**ARLINGTON COUNTY, VIRGINIA  
OFFICE OF THE PURCHASING AGENT  
INVITATION TO BID NO. 24-DES-ITB-360**

**ADDENDUM NO. 1**

Arlington County (hereinafter referred to as the "County") Invitation to Bid (ITB) No. 24-DES-ITB-336 for Air Handler Replacement is amended as follows:

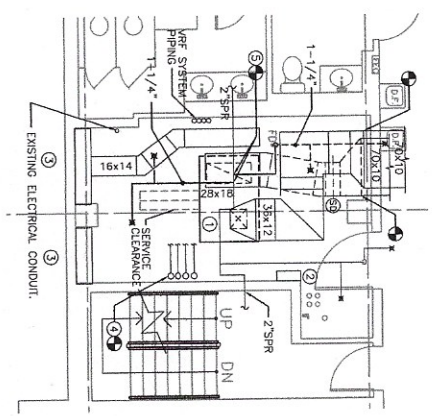
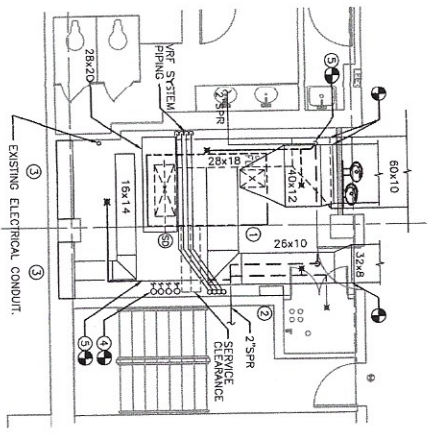
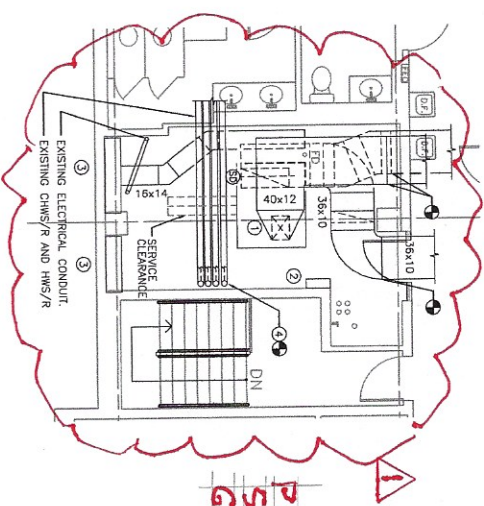
**I. DRAWING M-2-01:**

- A. The 7<sup>th</sup> Floor Plan-HVAC-New Work: Provide sprinkler work is similar to 4<sup>th</sup>, 5<sup>th</sup> and 6<sup>th</sup> Floor Plans.

**PROVIDE SPRINKLER  
SIMILAR TO 4TH, 5TH AND  
6TH FLOOR PLANS**

POWER RISER DIAGRAM - DEMOLITION

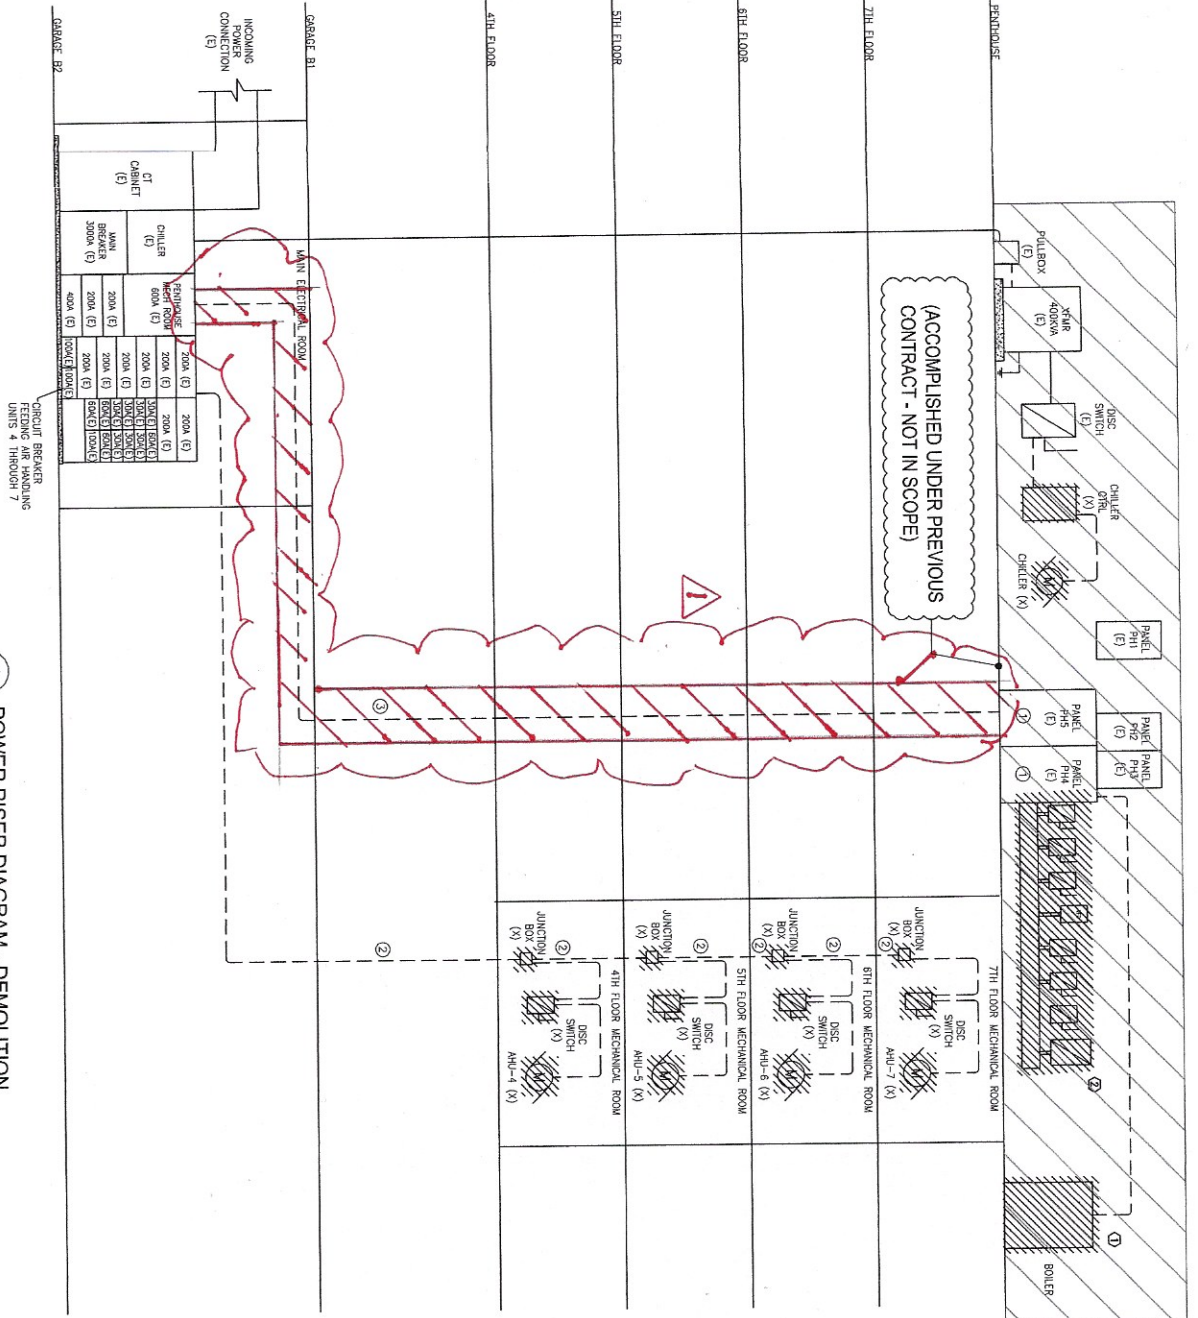
**II. DRAWING E-6-01:**

- A. Z Power Riser Diagram-Demolition: Feeder from Penthouse to the Main Switchgear demolition was accomplished under a previous Contract and is not in the Scope of this Contract.
- B. Riser Diagram Notes: Note 3 was accomplished under a previous Contract and is not in the Scope of this Contract.

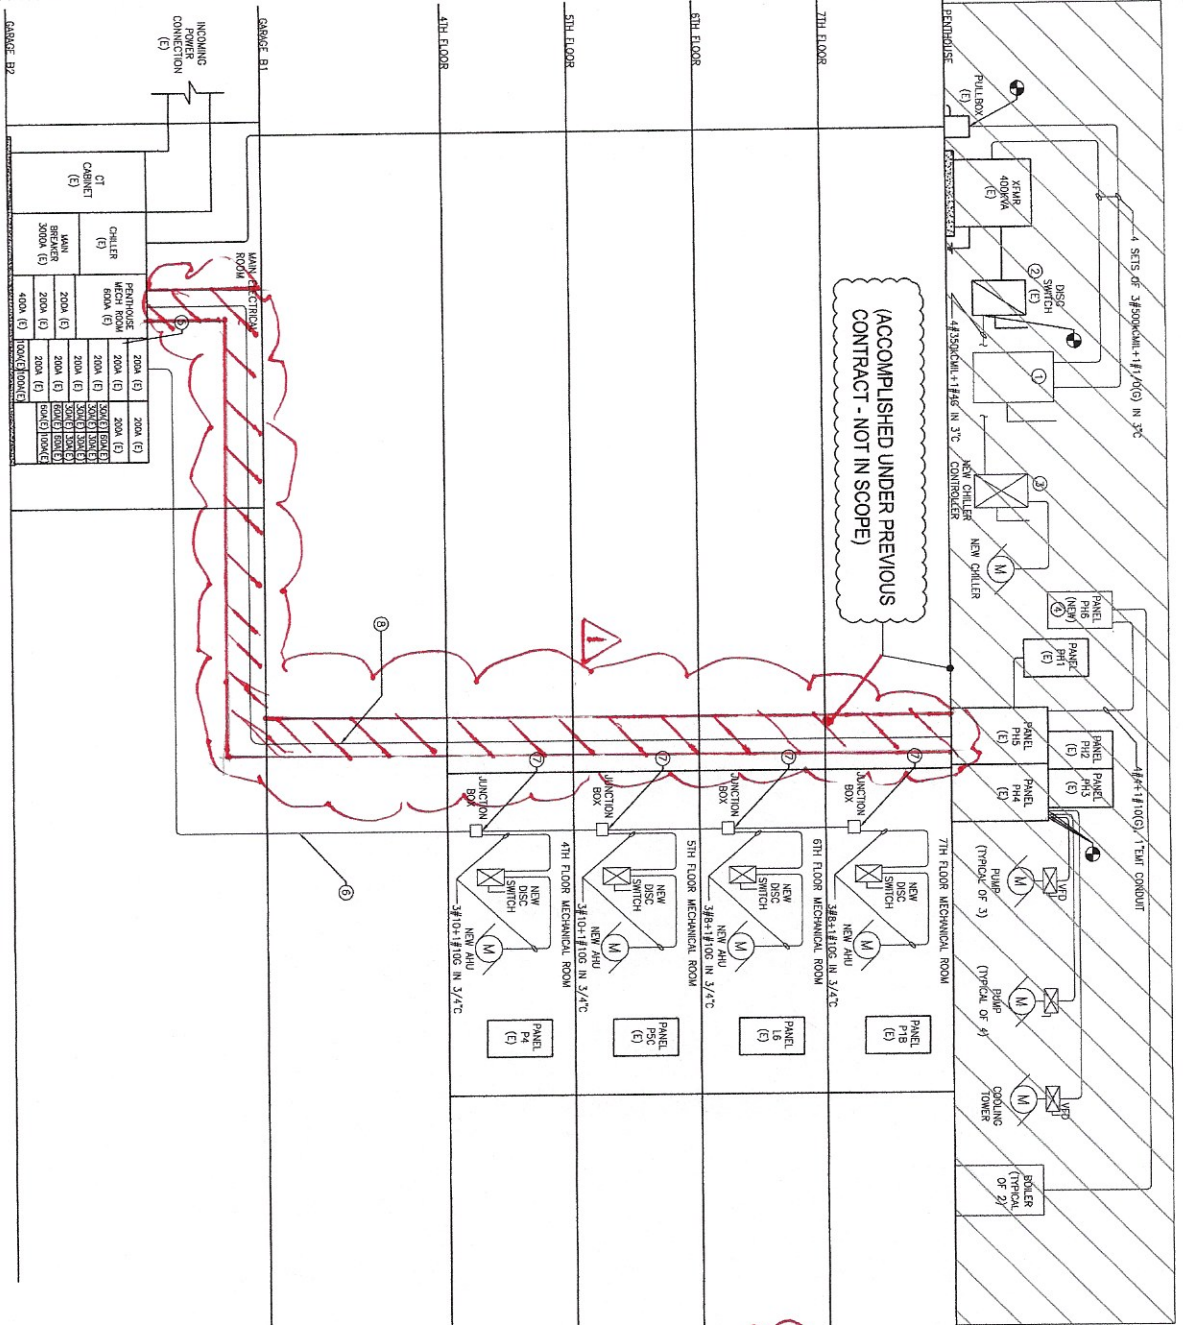
**III. DRAWING E-6-02:**

- A. Power Riser Diagram-New Work: Feeder from Penthouse to the Main Switchgear work was accomplished under a previous Contract and is not in the Scope of this Contract.
- B. Diagram Notes: Note 8 was accomplished under a previous Contract and is not in the Scope of this Contract.

- **Question #9:** Please provide the distance required for 2 sets of 4#300MCM + 1#1AWG in the two existing conduits, per note 8/E-6-02.

(ACCOMPLISHED UNDER PREVIOUS CONTRACT - NOT IN SCOPE)

**Answer #9:** Note 8/E-602 on Attachment C – Drawings was deleted under this addendum as the work was accomplished under a previous contract and is not in this project scope. Refer to Addendum 1, III. Drawing E-6-02.
